TECHNICAL BULLETIN

[Issue No.] T08-0017-A

[Title] Production discontinuation of CC-Link RS-232C interface module

[Relevant Models] AJ65BT-R2

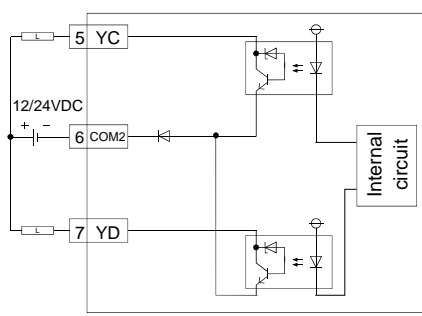
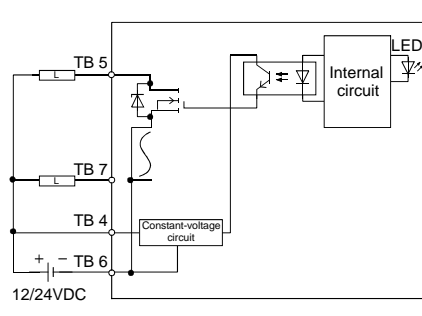
Item		Description		
Switch setting		Set switches of AJ65BT-R2N in same way as AJ65BT-R2.		
General-purpose output	When the AJ65BT-R2N is hardware version B or later	Wiring for general-purpose output need not be changed.		
	When the AJ65BT-R2N is hardware version A	<p>If a general-purpose output has been used in the AJ65BT-R2, connect a +24V wire to the general-purpose I/O terminal that is additionally provided to the AJ65BT-R2N.</p> <div style="display: flex; justify-content: space-around;"> <div style="text-align: center;"> <p>(AJ65BT-R2)</p>  </div> <div style="text-align: center;"> <p>(AJ65BT-R2N)</p>  </div> </div>		
E ² PROM register		<p>When the following have been saved to the E²PROM of the AJ65BT-R2, register the same setting to the E²PROM of the AJ65BT-R2N.</p> <ul style="list-style-type: none"> • Default value change in buffer memory • Auto-refresh buffer assignments • User registration frame 		
Sequence program		<p>A program created for the AJ65BT-R2 can be used in the AJ65BT-R2N without any changes.</p> <p>Note that, however, the transmission performance of the AJ65BT-R2N has been upgraded up to approx. 10% compared with that of the AJ65BT-R2, resulting in a faster response speed. Because of this, the external device may not be able to respond to a send request from the AJ65BT-R2N.</p> <p>Therefore, perform the following.</p> <ul style="list-style-type: none"> • Review the processing of the external device. • Delay the transmission start by the sequence program. 		
External dimensions		The external dimensions are different between the AJ65BT-R2 and the AJ65BT-R2N as shown below.		
		<table border="1" style="width: 100%; border-collapse: collapse;"> <thead> <tr> <th style="width: 50%;">AJ65BT-R2</th> <th style="width: 50%;">AJ65BT-R2N</th> </tr> </thead> <tbody> <tr> <td style="text-align: center;">80(H) × 170(W) × 63.5(D)[mm]</td> <td style="text-align: center;">80(H) × 170(W) × 47(D)[mm]</td> </tr> </tbody> </table>	AJ65BT-R2	AJ65BT-R2N
AJ65BT-R2	AJ65BT-R2N			
80(H) × 170(W) × 63.5(D)[mm]	80(H) × 170(W) × 47(D)[mm]
